Service Bulletin

No. : MZ02-032

Model: SR5200/SR6200/SR7200

Subject: Pop noise

* Version 1 P.C.Board (7020 06076 001-0) : Please apply the modification mentioned below (Page2 to 4).

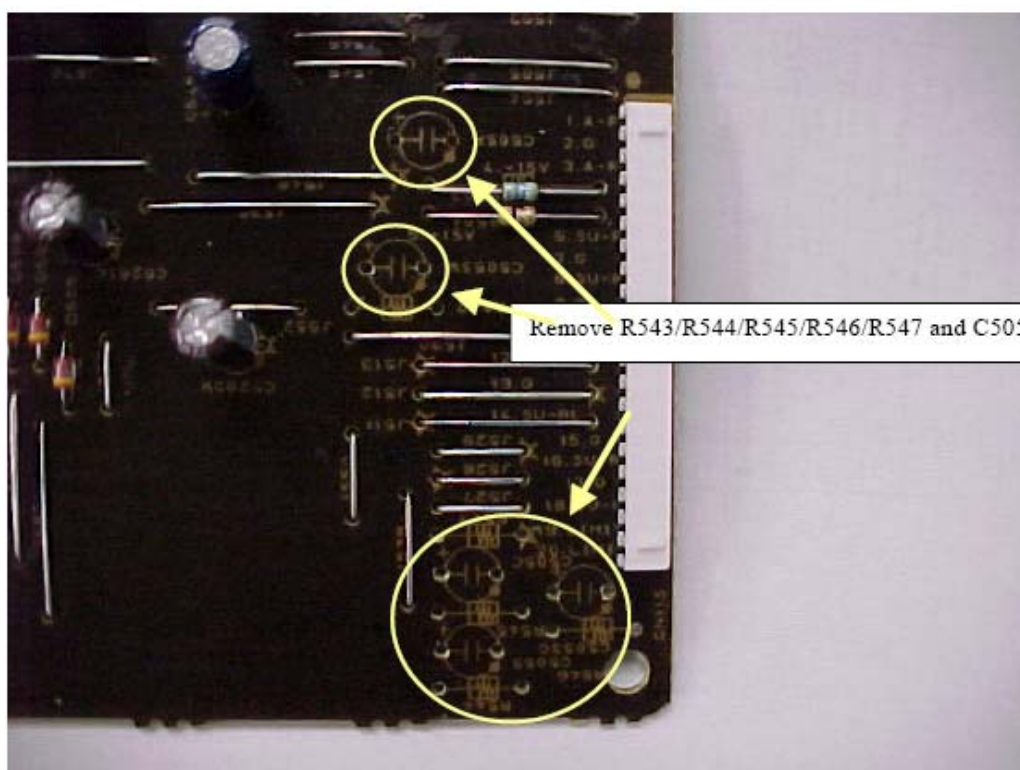
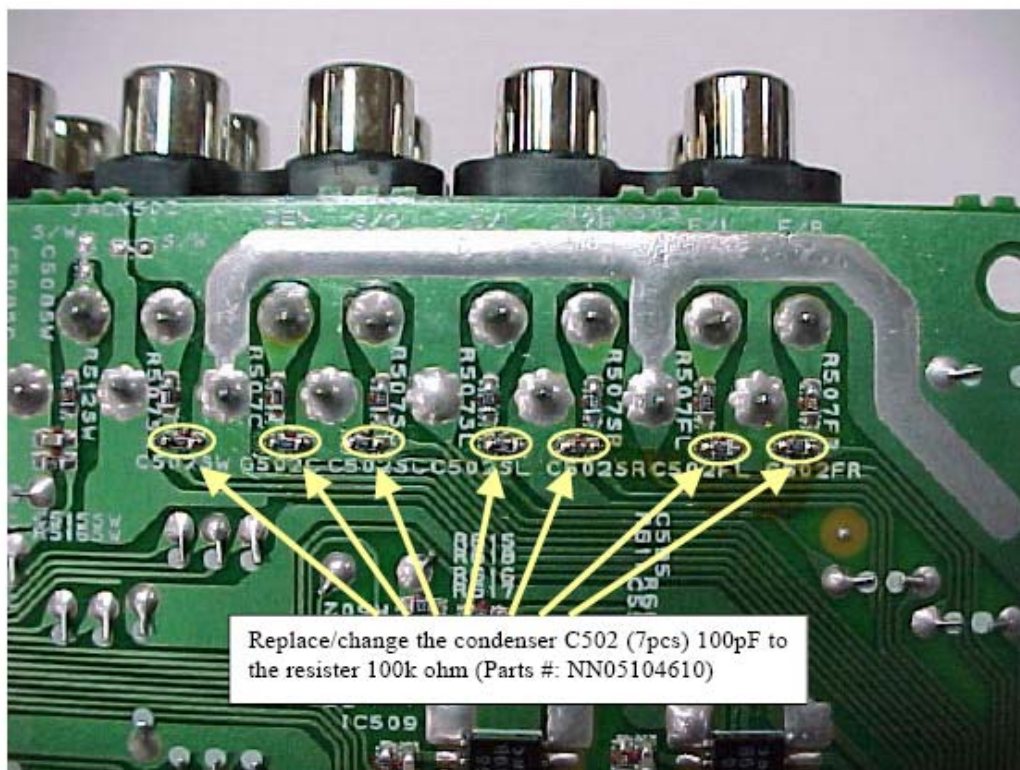
Symptom: A pop noise appears when you stop playing or skip tracks on CD playback when using a Digital connection. Pop noise appears when the Main volume is changed 74dB to 75dB (Mute).
